Technical Note 1

Project Name:	Cringle Road, Levenshulme
Document No:	LM20066-DYSE-XX-ZZ-TN-C-0001
Revision:	P02
Date:	25/02/22
Distributed to:	Design Team
Originated by:	Andy James
Client:	Towerhouse Systems
Content:	Drainage Design Technical Note

FLOW CONTROL MANHOLE S1.28
PLAN

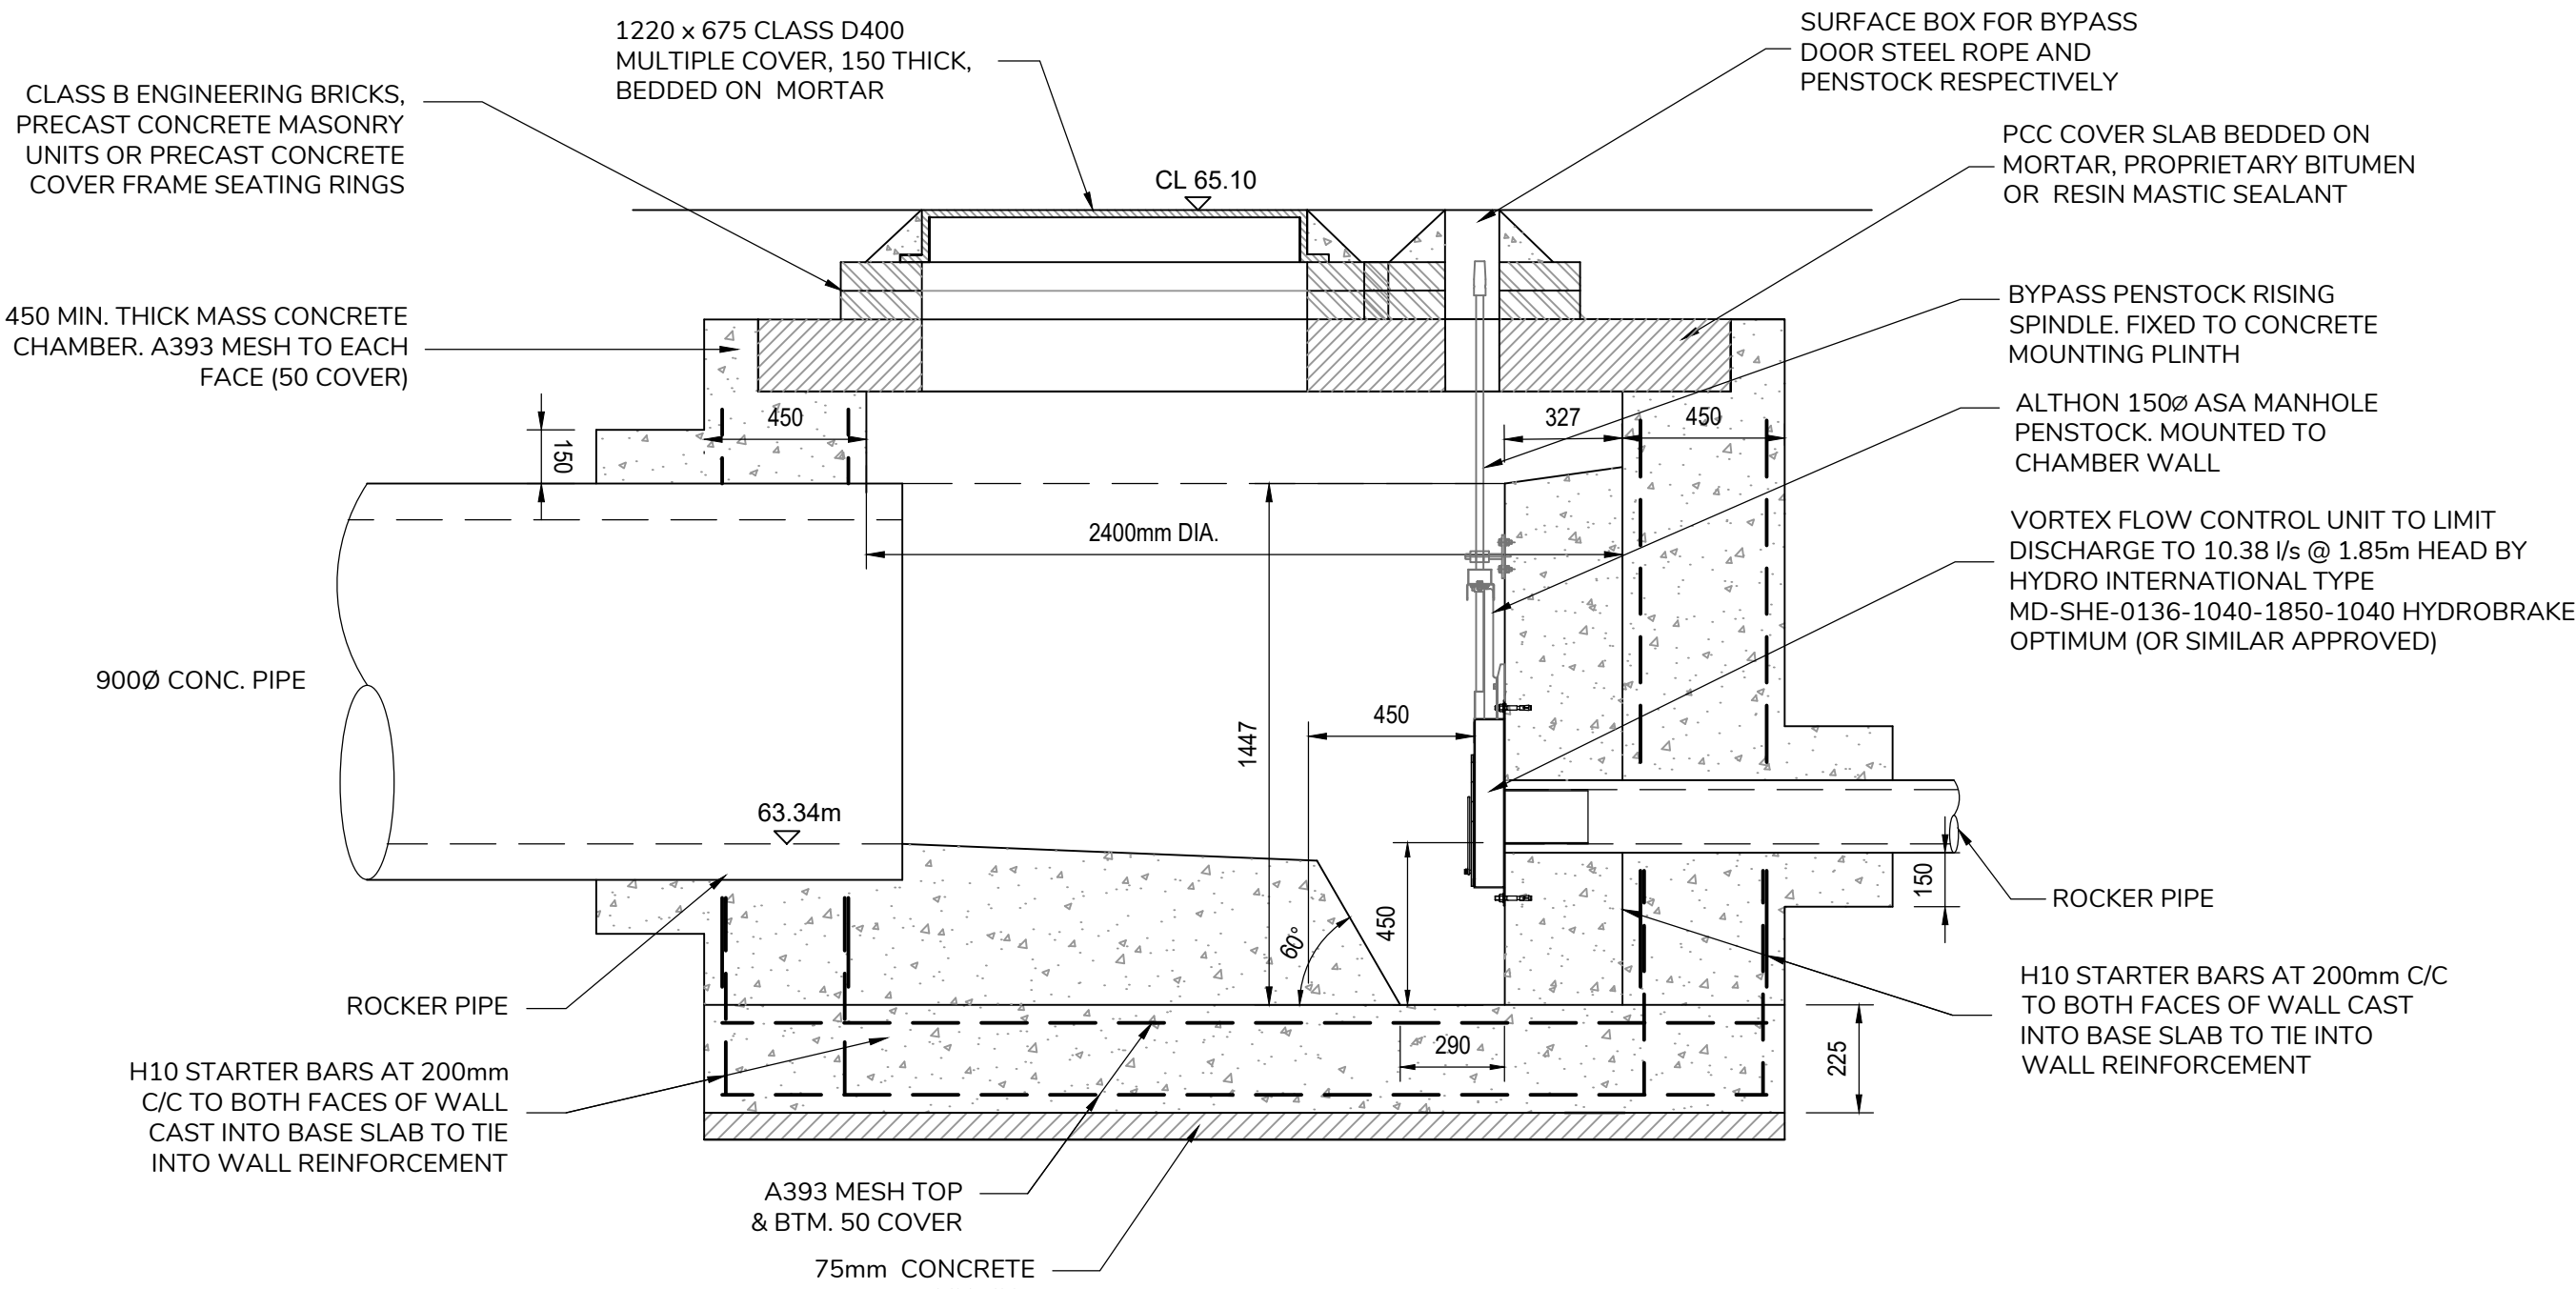
1. Please provide a drainage strategy report/technical note for the submitted scheme.
2. Section 104 drawing // calcs indicate flow control 10.38 l/s; prev. submitted strategy (attached) during LLFA discussions was 2 l/s. Please explain within report/technical note.
3. Please present evidence of UU acceptance of proposed connection (if using previously obtained consent, please check in-date).
4. Prev. submitted strategy indicated simulation would be to 40% CC (attached). We would recommend that the simulation is run for 40% climate change (not 30%) to test the upper band in line with current guidance.

However, in line with the LLFA's request, the drainage model was also run with a 40% allowance for climate change. This resulted in circa 21m³ of flooding at the control chamber (S1.28) which is positioned at the boundary of the site,
